CITY OF DULUTH
Community Planning Division

File Number	PL17-167	Contact	Jenn Moses, jmoses@duluthmn.gov	
Type	Concurrent Use Permit	Planning Commission Date		November 14, 2017
Deadline for Action	Application Date	October 5, 2017	60 Days	December 4, 2017
	Date Extension Letter Mailed	October 24, 2017	120 Days	February 2, 2017
Location of Subject	1001 E 9 th Street			
Applicant	DIV Ventures, LLC	Contact		
Agent	John Westlund	Contact		
Legal Description	See attached			
Site Visit Date	October 29, 2017	Sign Notice Date	October 30, 2017	
Neighbor Letter Date	N/A	Number of Letters Sent	N/A

Proposal

Applicant is requesting 6 parking spaces located in the right of way of N 10th Avenue E. Area is currently paved and used for parking.

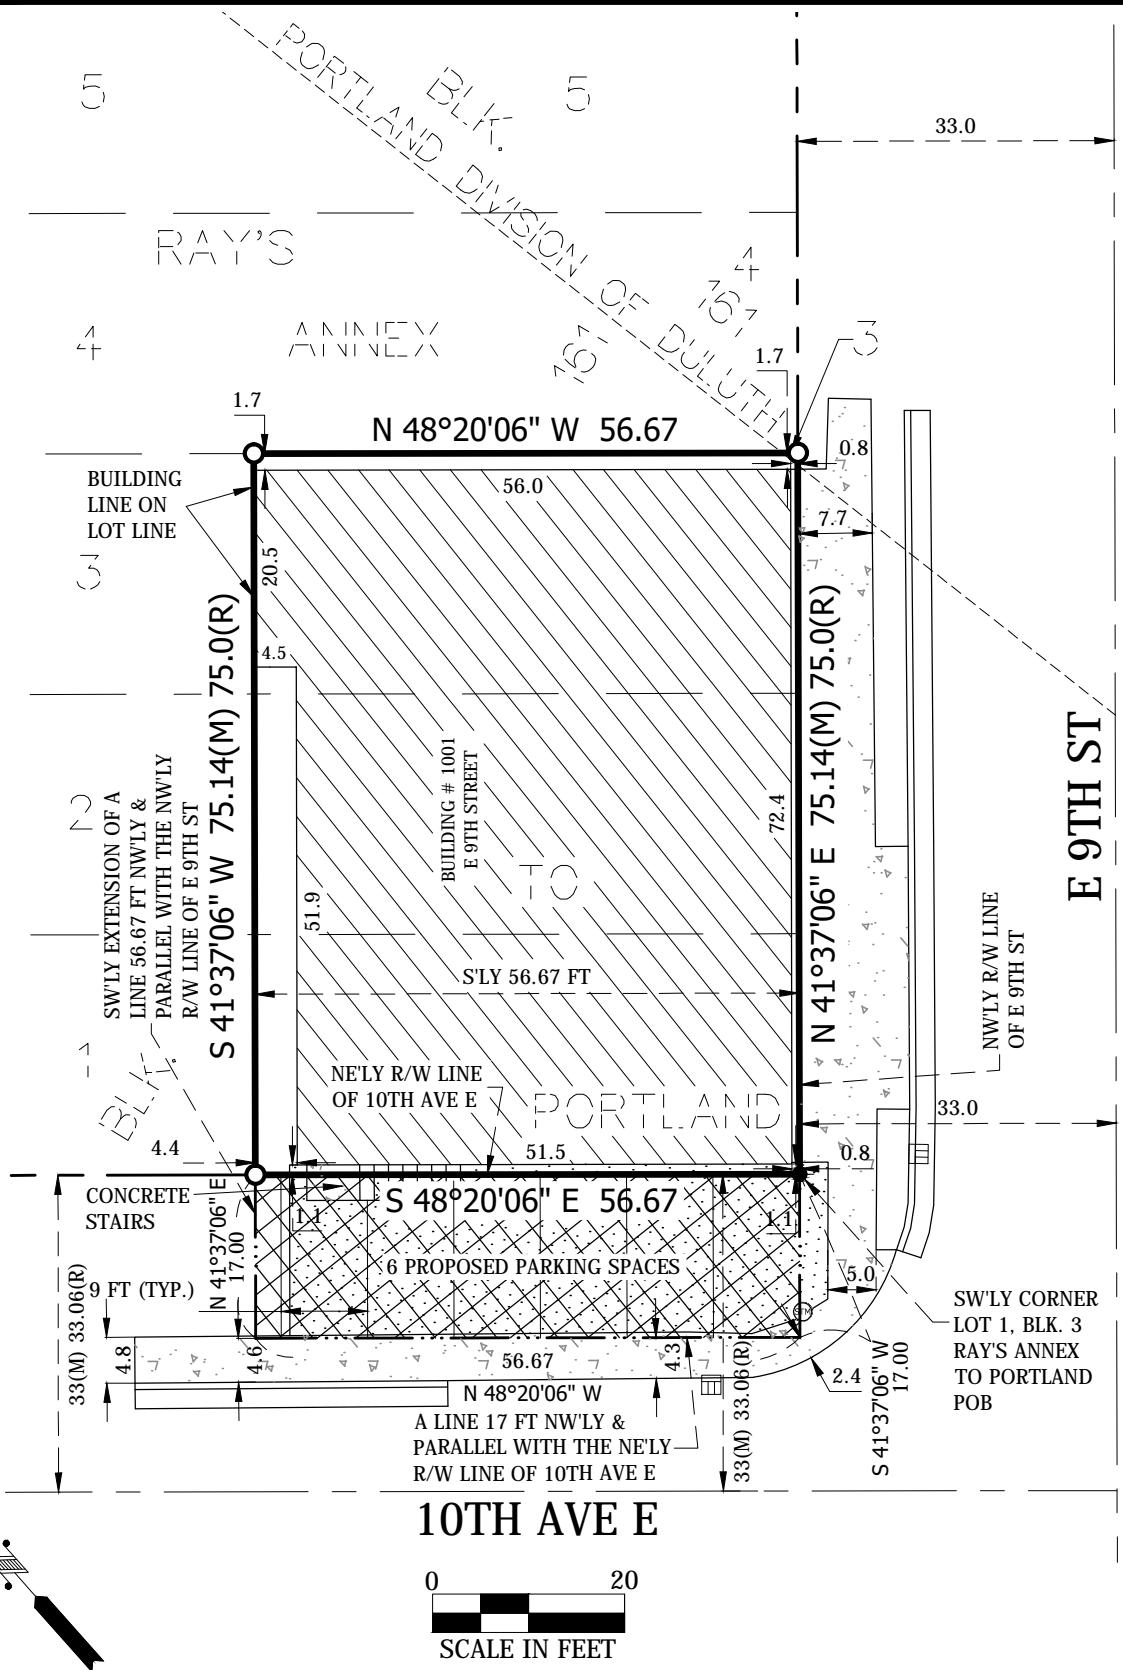
- 1) Area proposed for parking is currently paved with asphalt. A concrete driveway apron was installed at some point in the past, at a width that would accommodate approximately three cars. The adjacent curb areas have deteriorated to a point where it appears additional vehicles are driving over the curb to park in the area.

- 2) According to City Engineering, aerial photos indicate this area has been used as parking at least as early as 1979.
- 3) Applicant is requesting a total of 6 parking spaces, which would encroach to a depth of 17' into the right of way. According to the property survey, this distance encroaches into the existing sidewalk approximately 1 foot. In addition, due to the curve radius, the spot closest to E 9th Street would leave only 2.4 feet of sidewalk clearance, which is not sufficient to provide pedestrian egress (sidewalk depth in this area ranges from 4 to 5 feet). Staff recommends that the space closest to E 9th Street be eliminated.

- 4) Applicant states he uses a few feet on the northwest side of the paved area for snow storage, and when snow gets high, it is removed from the site. Vegetation along the northwest boundary could be damaged if snow is plowed into it, and excess snow could spill into adjacent sidewalk. Depending on height and proximity of stored snow to the right of way of N 10th Avenue E, it could provide an obstruction from sight lines, obscuring vehicles backing out of the parking spaces. Given the narrow space, snow should be hauled off site to prevent problems.

- 5) No crashes or other safety issues have been documented with existing parking lot.
- 6) The City stormwater engineer noted that impervious surfaces within the right of way contribute to stormwater costs, and that parking lots on private property are normally required to pay a stormwater fee to cover City expenses. City Engineering also notes that the deteriorated curb could cause problems for stormwater flow, and that improvements to the site could ensure water is routed appropriately.

- 7) Since parking lots on private property are required to provide landscaping, staff finds it is appropriate to include landscaping as part of this parking request. A parking lot of this size would require trees be planted so that at maturity 30% of the parking area is shaded. As tree planting might be difficult in this area, alternative landscaping could include shrubs and/or perennials, likely in the area closest to E 9th Street in lieu of one parking space.

- 1) Parking space closest to E 9th Street be eliminated, for a total of 5 parking spaces.
- 2) The curb cut and driveway apron be reconstructed, in accordance with City Engineering, to direct stormwater flow and clearly communicate to drivers where parking spaces are located.

- 3) Parking area be painted to delineate parking spaces, with parking dimensions per UDC Section 50-24.
- 4) All snow shall be hauled off-site when cleared.

- 5) Applicant either provide 30% tree canopy coverage, or submit an Alternative Landscaping Plan for the concurrent use permit area, which must be approved by the Land Use Supervisor.

- 6) All above improvements shall be completed prior to October 31, 2018.
- 7) Property owner shall pay an additional stormwater fee to cover this area of impervious surface.
